CASANDRO WASH DAM
OUTFALL STRUCTURE

FLOOD CONTROL DISTRICT OF MARICOPA COUNTY

PROJECT Casandro wash PAGE 1 OF
DETAIL In Let Structure COMPUTED KNH DATE 5/9
CHECKED BY DATE

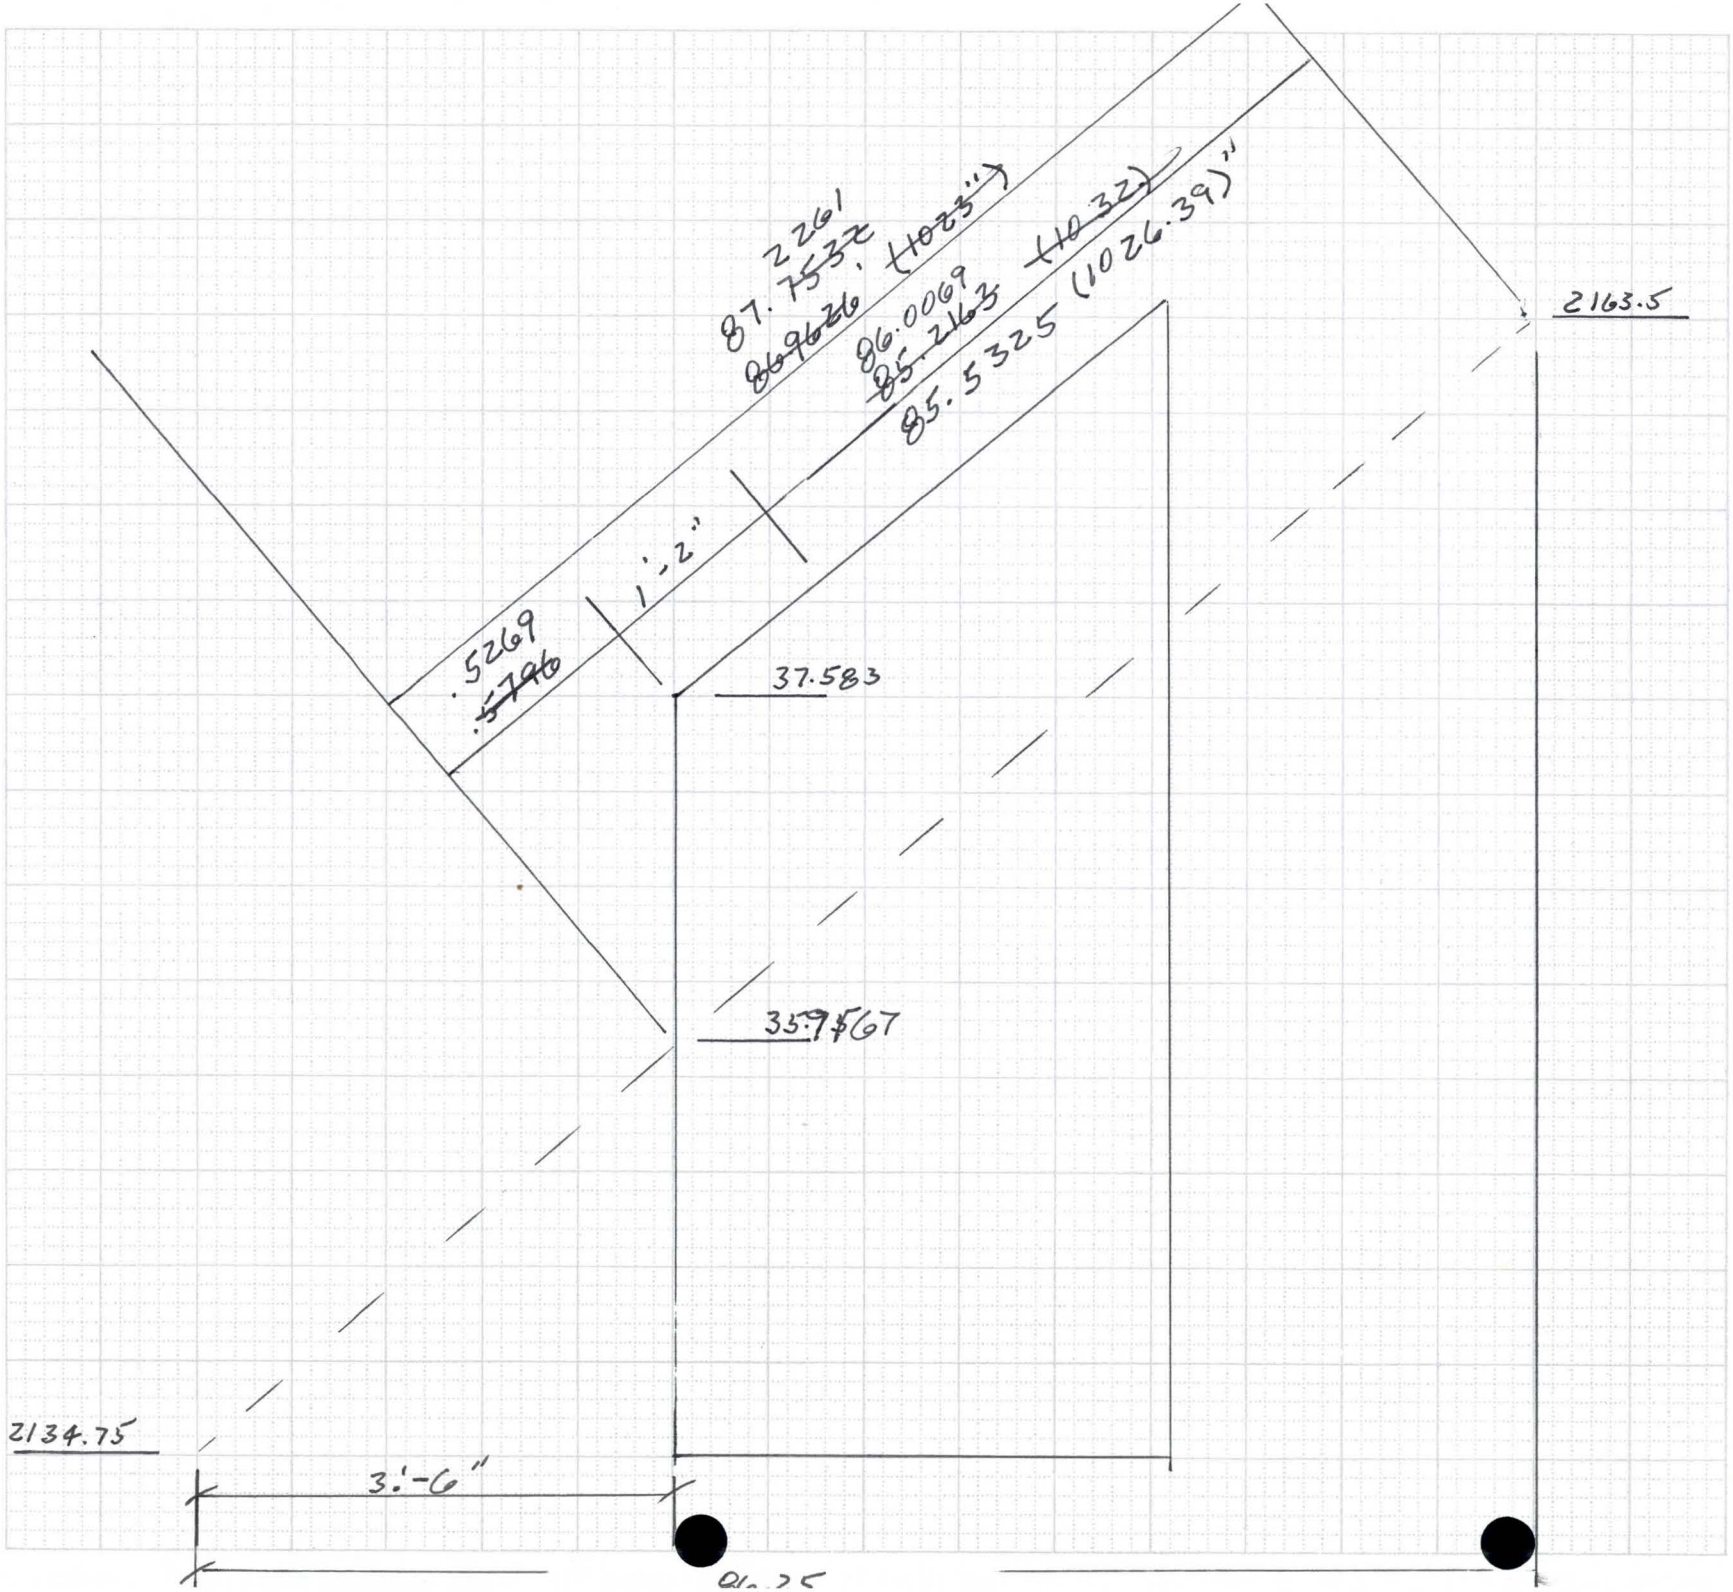
2. Please verify that the gate is to be non-self contained.

3. We request verification of the "H" (linear distance from gate center line to base of lift) dimension currently shown on our drawing as 1005 inches. Note that this dimension is critical and must be accurate to insure proper stem length and support. (1024) 1032

Our drawing sht.11 shows the view of slide gate, with a rail on the top, which makes it as self contained.As the stem is so long, Les thinks we may not need a self contained one . Therefore a non -self contained gate is shown on the shop drawings.

Diff = 1032 - 1005 = 27"
Shop Dwgs

we are Coming up with about 27" Longer

SECTION B-B

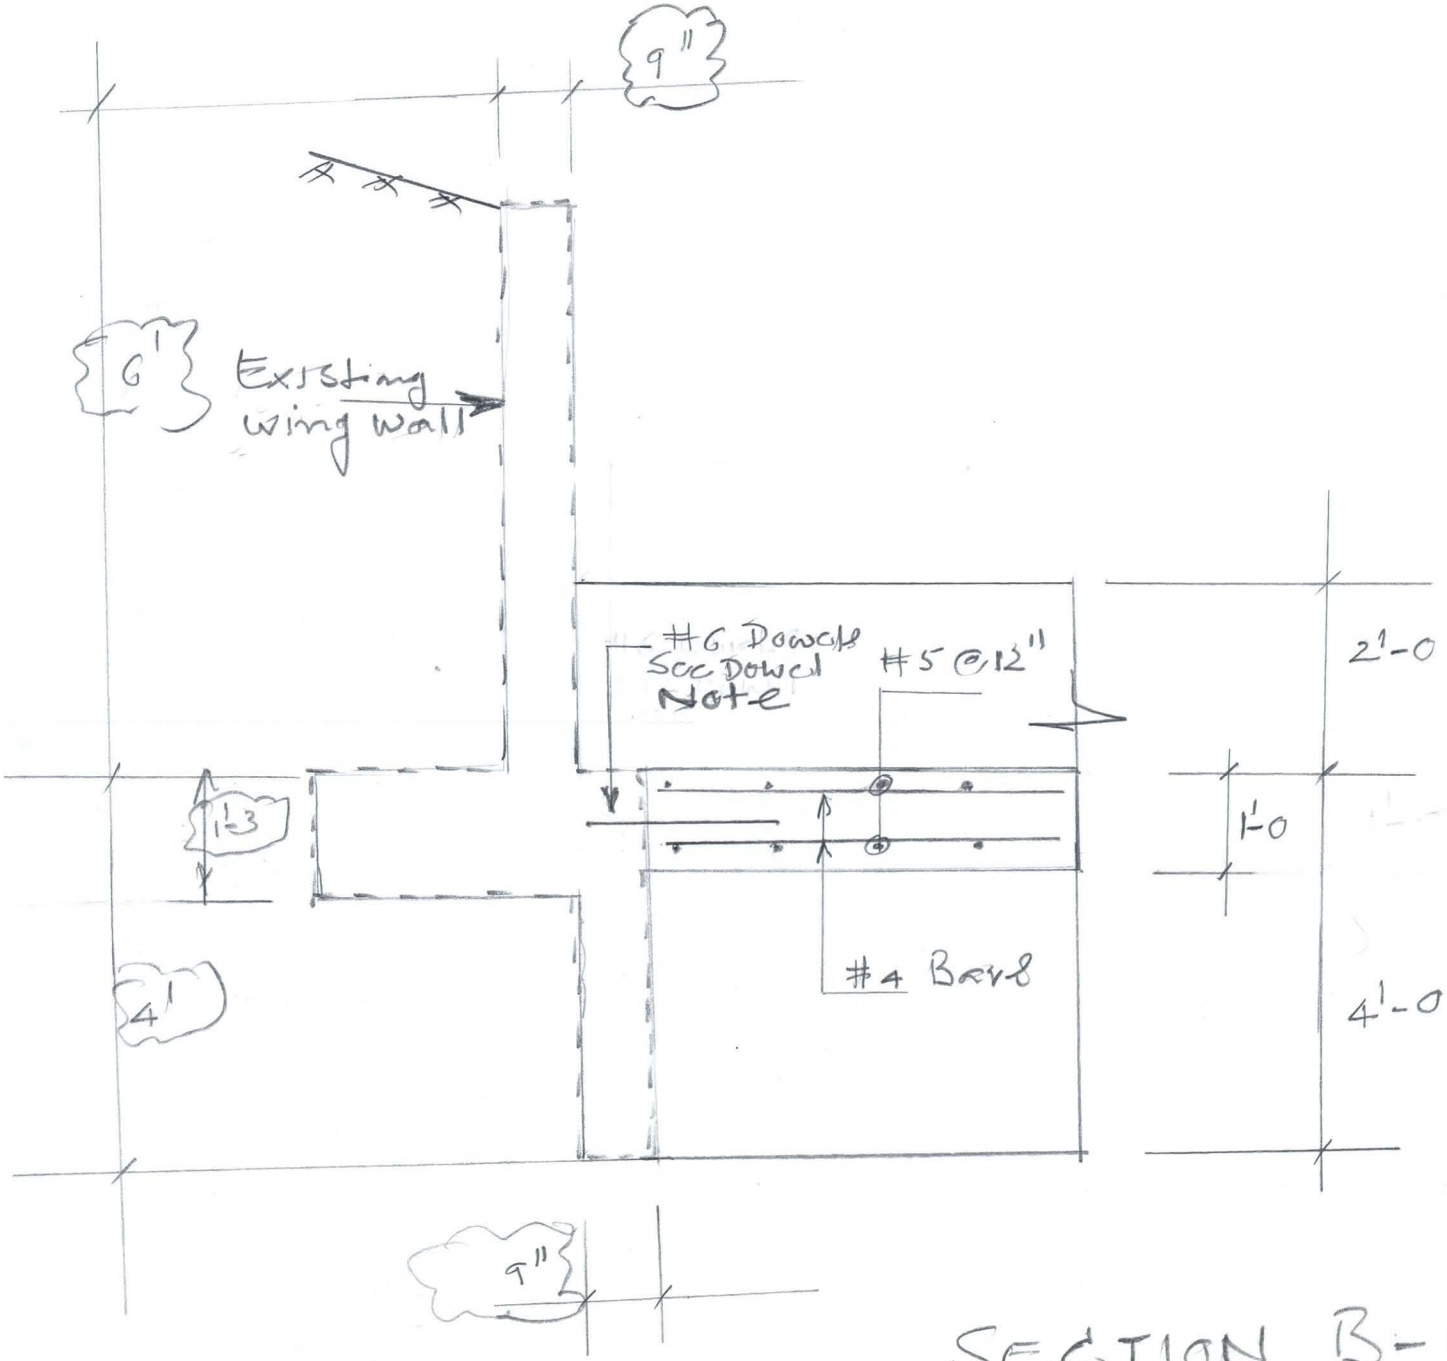
1. Revise wall section CC on sheet 9 of plan set to show 5'-0" extension of #8 @ 6" horizantal leg in addition to # 5 @ 12" of footing steel.

2. Sheets 1 and 3 of structural calculations: The approach used in calculating the distance of the resulant X from the toe is incorrect.The footing pressures will change slightly and the reinforcing may remain the same. However the computations shall be revised to show the correct numbers.
